County of San Diego  
Planning & Development Services  
**BUILDING DIVISION**

**ACCESSIBILITY CORRECTION LIST**

Multifamily Housing

**Common-Use Shower, Bathing,  
and Locker Room Facilities**

**CBC FIGURE 11A-1A(b) –  
INTERNATIONAL SYMBOL OF ACCESSIBILITY  
(WHITE FIGURE ON BLUE BACKGROUND EQUAL TO  
COLOR NO. 15090 IN FEDERAL STANDARD 595B)**

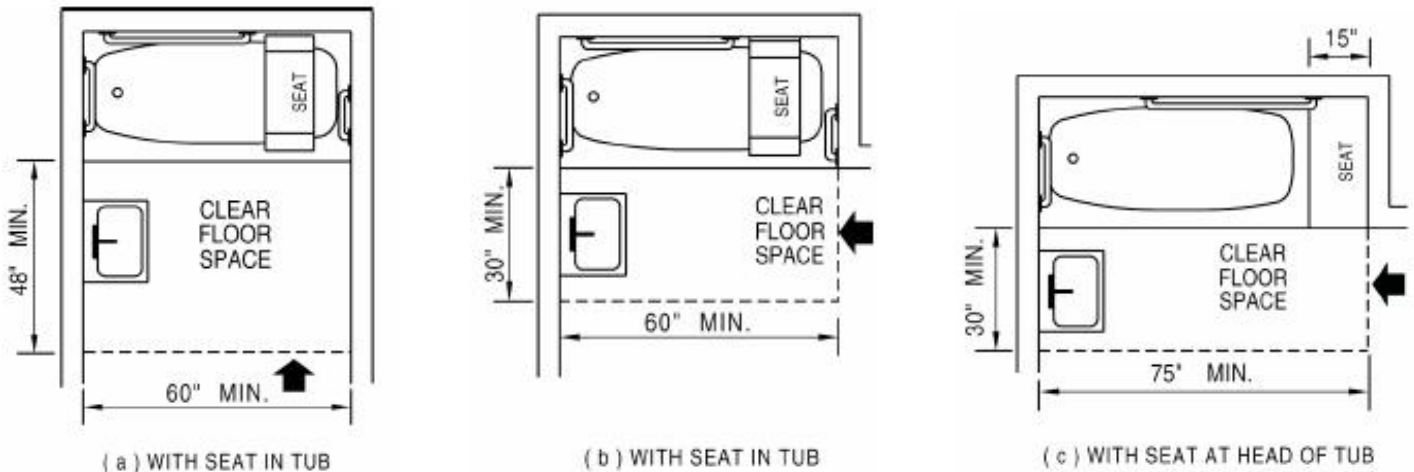
33. Identify at least 1% of lockers provided – but not less than one of each type – as accessible and on an accessible route.  
*CBC 1127A.6.1*
34. All portions of accessible lockers shall be within reach ranges per accessibility correction list 5A.  
*CBC 1127A.6.1 and CBC 1127A.9.5*
35. Specify locker-opening hardware complying with the following:
- ☐ Operable with maximum 5 pounds of force
  - ☐ Operable with one hand and without tight grasping, pinching, or twisting of wrist  
*CBC 1127A.9.6.4*
36. Provide signage including International Symbol of Accessibility per CBC Figure 11A-1A(b) at each accessible locker and coordinate with signage schedule.  
*CBC 1127A.7.1*

**CBC FIGURE 11A-9E – BATHTUB CLEAR FLOOR SPACE**

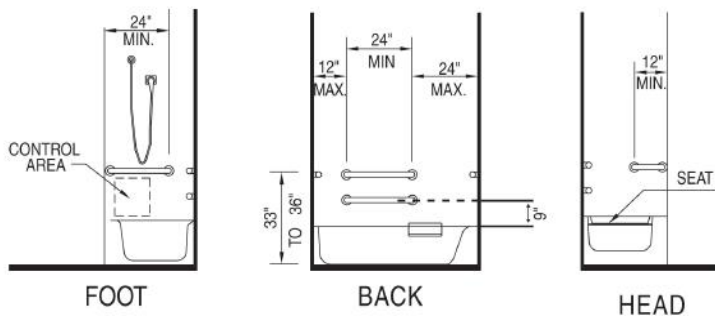
21. Specify whether accessible bathtub will include an in-tub seat or built-in seat at head of tub.  
*CBC 1127A.5.2(2)*
22. For bathtub with in-tub seat allowing only forward approach, dimension minimum 48-inch by 60-inch clear space per CBC Figure 11A-9E(a).  
*CBC 1127A.5.2(1)*

23. For bathtub with in-tub seat allowing parallel approach, dimension minimum 30-inch by 60-inch clear space per CBC Figure 11A-9E(b).  
*CBC 1127A.5.2(1)*

24. For bathtub with built-in seat at head of tub and allowing only forward approach, dimension minimum 48-inch by 75-inch clear space similar to CBC Figure 11A-9E(a) and CBC Figure 11A-9E(c).  
*CBC 1127A.5.2(1)*

25. For bathtub with built-in seat at head of tub and allowing parallel approach, dimension minimum 30-inch by 75-inch clear space per CBC Figure 11A-9E(c).  
*CBC 1127A.5.2(1)*

26. For bathtub with built-in seat at head of tub, dimension minimum 15-inch seat depth per CBC Figure 11A-9E(a).  
*CBC 1127A.5.2(2)*
27. Detail bathtub grab bars complying with the following:

**CBC FIGURE 11A-9F(a) –  
BATHTUB GRAB BARS WITH IN-TUB SEAT**

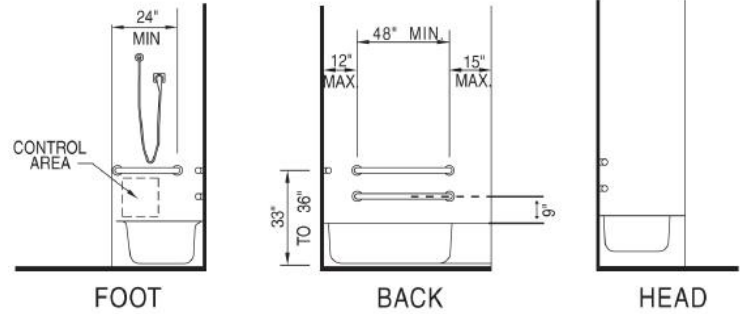
- ☐ For bathtub with in-tub seat, grab bar lengths and mounting heights per CBC Figure 11A-9F(a)
  - ☐ For bathtub with built-in seat at head of tub, grab bar lengths and mounting heights per CBC Figure 11A-9F(b)

29. Dimension bathtub faucets and controls per CBC Figure 11A-9F.  
*CBC 1127A.5.4*
30. Provide bathtub faucets and other controls complying with the following:
- ☐ Operable with maximum 5 pounds of force
  - ☐ Operable with one hand and without tight grasping, pinching, or twisting of the wrist  
*CBC 1127A.5.4*
31. Provide sprayer units complying with the following:
- ☐ Minimum 60-inch long flexible hose
  - ☐ Installed with top of mounting bracket maximum 48 inches above shower floor
  - ☐ Capable for use as fixed shower head and hand-held shower  
*CBC 1127A.5.2(5) and CBC 1127A.5.3(4.2)*
32. Specify any enclosures provided for bathtubs shall comply with the following:
- ☐ No tracks mounted on rims
  - ☐ No obstruction of shower controls
  - ☐ No obstruction of transfer from wheelchair to bathtub seat or into bathtub  
*CBC 1127A.5.2(6)*

CBC FIGURE 11A-9I – ROLL-IN SHOWER

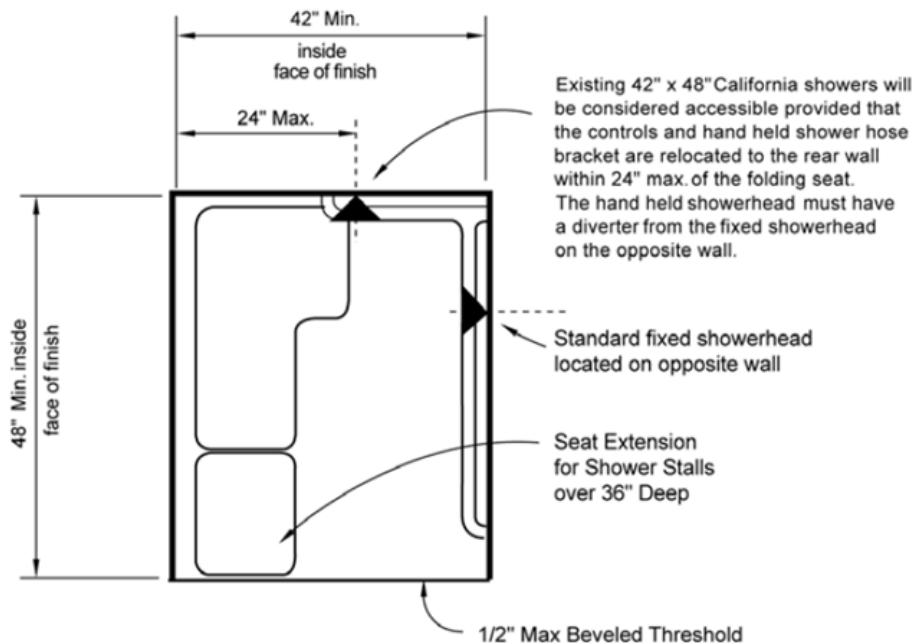
**Exception:** Minimum 36-inch depth if shower entrance enclosed to require parallel approach
- o Full-opening width on long side
- ☐ Roll-in shower per CBC Figure 11A-9I:
  - o Minimum 42-inches wide between wall surfaces
  - o Minimum 48-inches deep
  - o Minimum 42-inch-wide entrance opening
- ☐ Roll-in shower per CBC Figure 11A-9K:
  - o Minimum 60-inches wide between wall surfaces
  - o Minimum 36-inches deep
  - o Minimum 36-inch-wide entrance opening

CBC FIGURE 11A-9K – ROLL-IN SHOWER

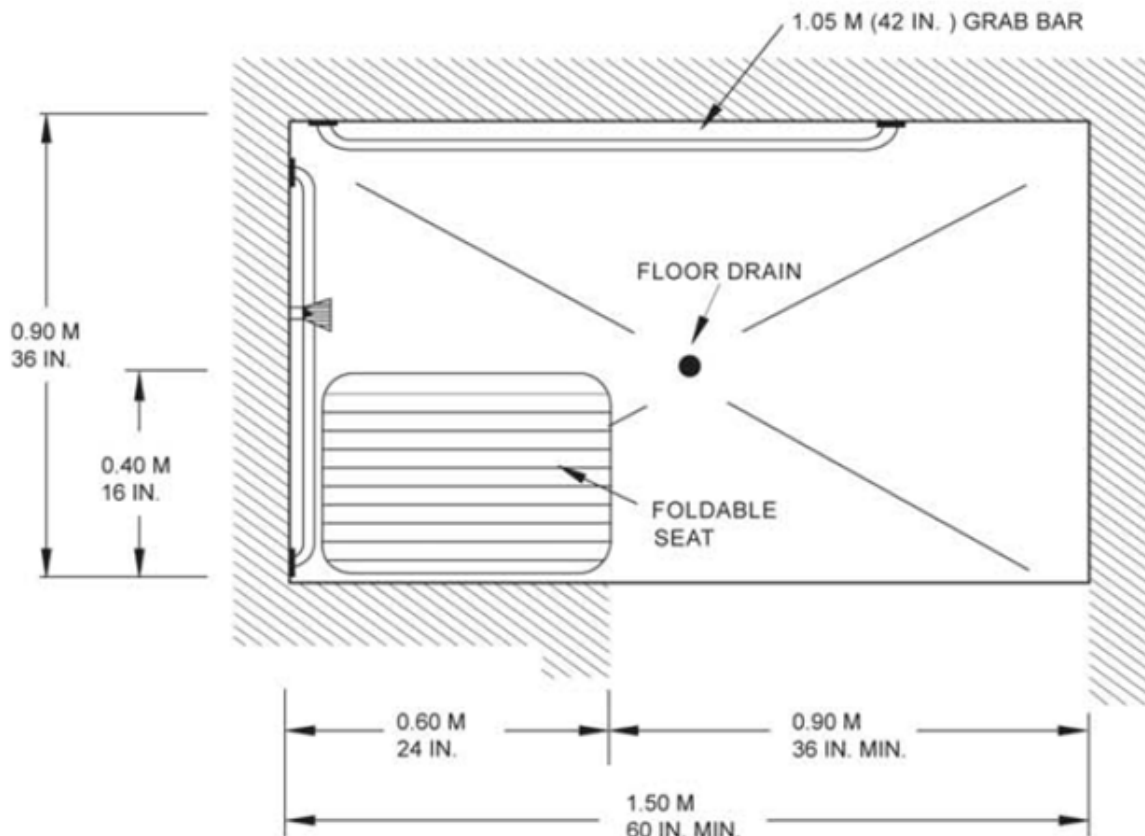
- ☐ Mounted minimum 33 inches and maximum 36 inches above shower floor
- ☐ L-shaped and mounted on walls opposite and adjacent to front edges of seat and not extending over seat
- Exception:** Grab bar configurations in CBC Figure 11A-9J and CBC Figure 11A-9K
- ☐ Grab bar gripping surfaces minimum 1¼ inches and maximum 1½ inches in diameter/width or shape providing equivalent gripping surface
- ☐ 1½-inch (absolute) space between grab bars and adjacent walls
